**ADDENDUM NO. #2 TO THE
TENDER DOCUMENTS**

PROJECT: Town of Bishop's Falls, Linear Park Main Street

ADDENDUM DATE: April 25, 2022

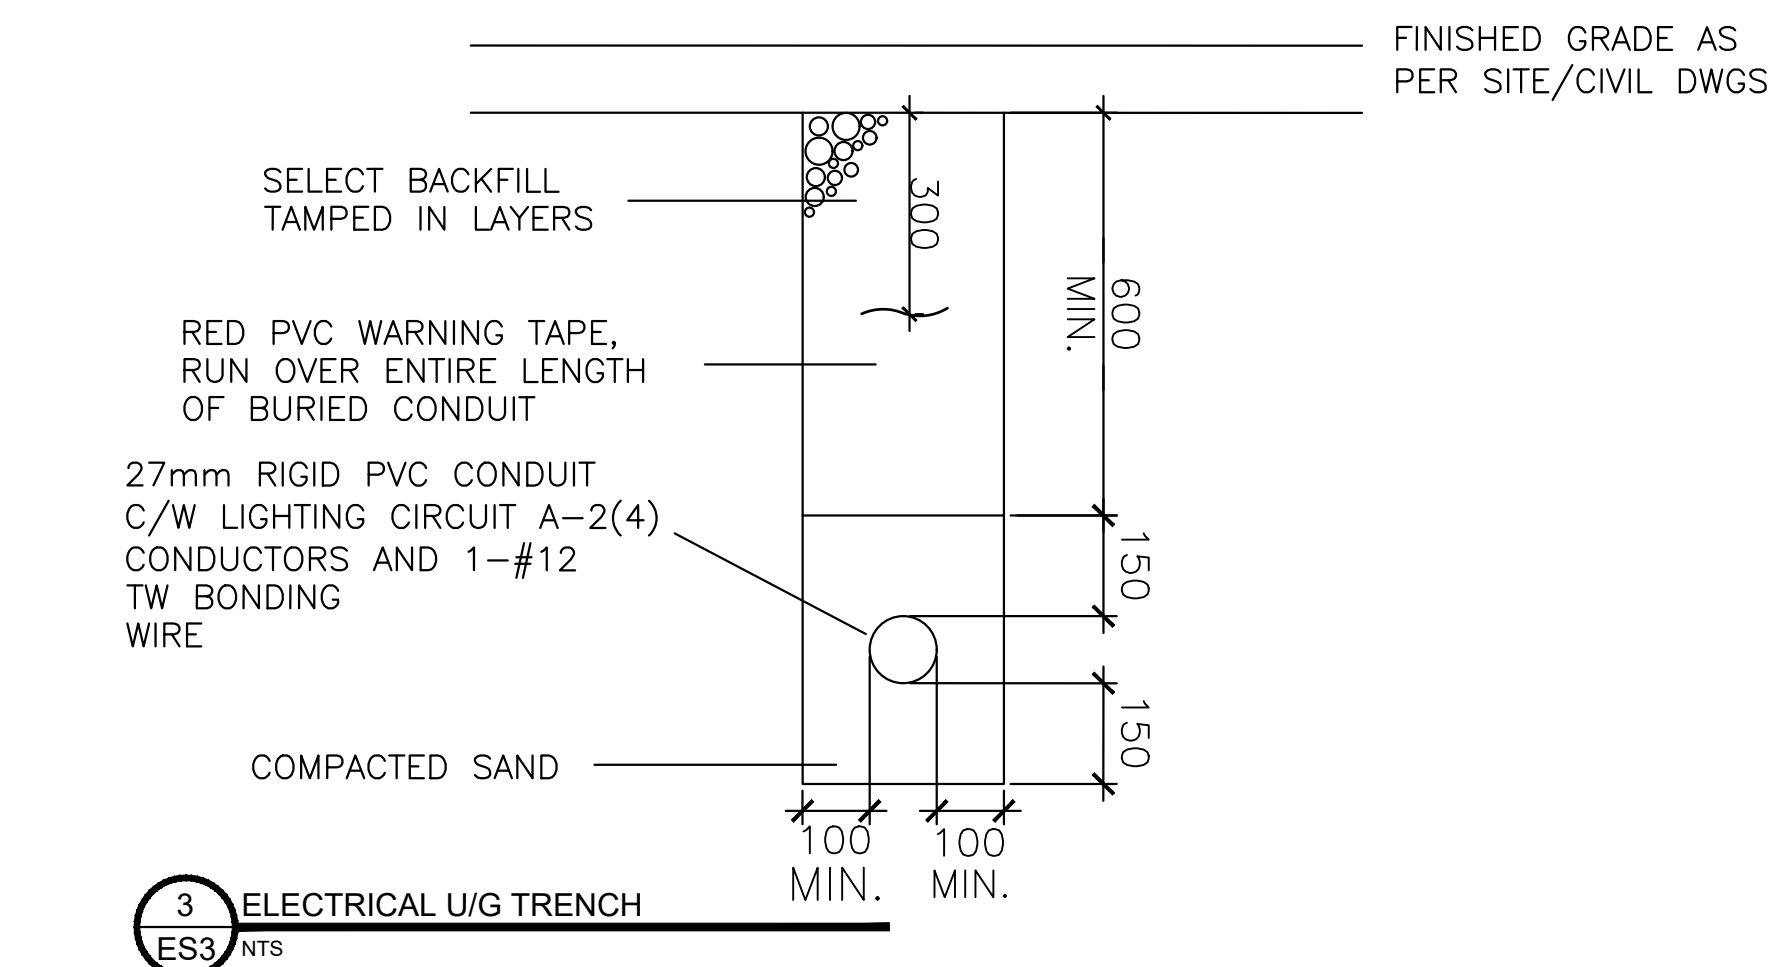
- .1 Do all conduits from the pole mounted panel need to be rigid galvanized conduit and adapting to PVC underground?
NO Rigid PVC is acceptable.
- .2 Do we require ground wires in conduits for the receptacle circuits and if so what size?
See sketch attached, ground Wires will be same size as hot conductors.
- .3 Some power runs to poles for receptacles as per the addenda are in my opinion not manageable as per the following.
See revised drawings
- .4 The lighting runs for all the poles are manageable as per the addenda with the possible exception of poles 13 and 15 where we will have 1 x ¾" & 2 x 1" & 1 x 2" conduit entering the bases.
See revised drawings
